# EMBARK H&H HOMES

## PLAN REVISIONS

EMBARK (GARAGE LEFT)  
H&H HOMES

TITLE  
REVISION LOG

TITLE  
ELECTRICAL PLAN

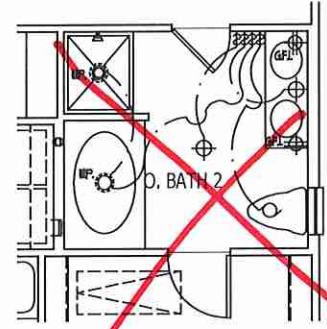
\*see CPI PLAN

SHEET: 3 OF 10  
S-1.2a  
MONO SLAB  
FOUNDATION PLAN

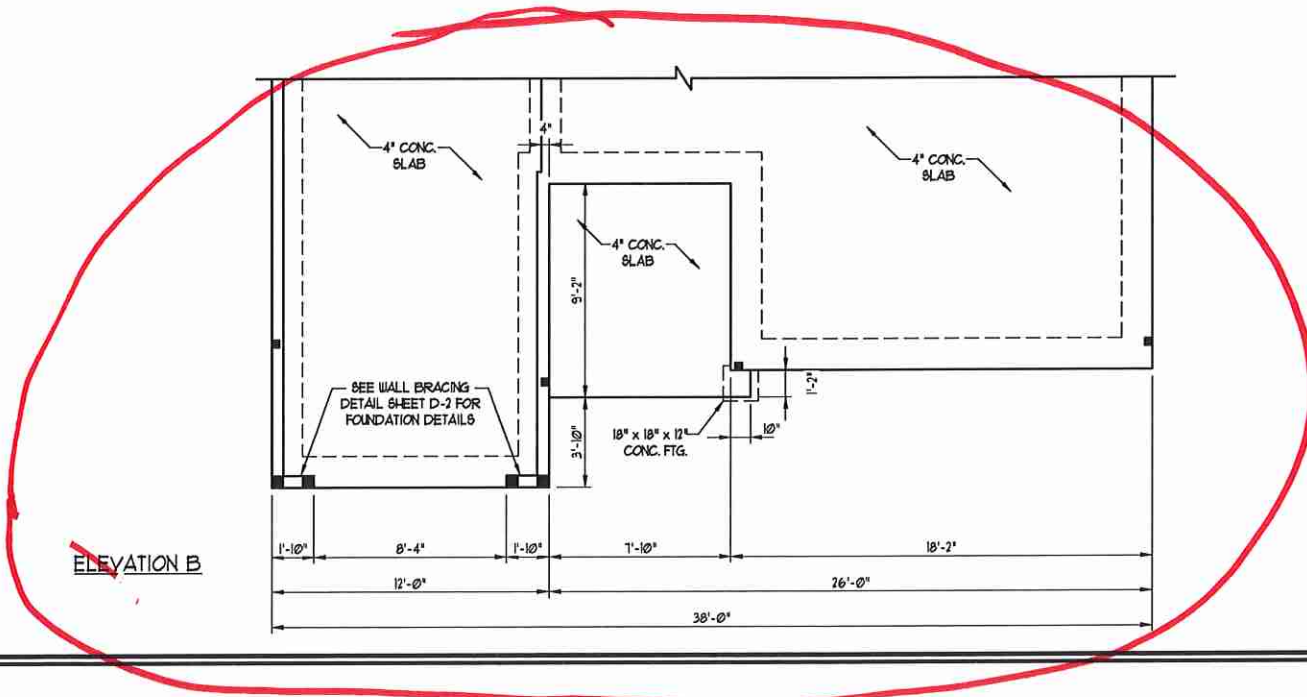
see elev.  
B  
~~ELEVATION A~~
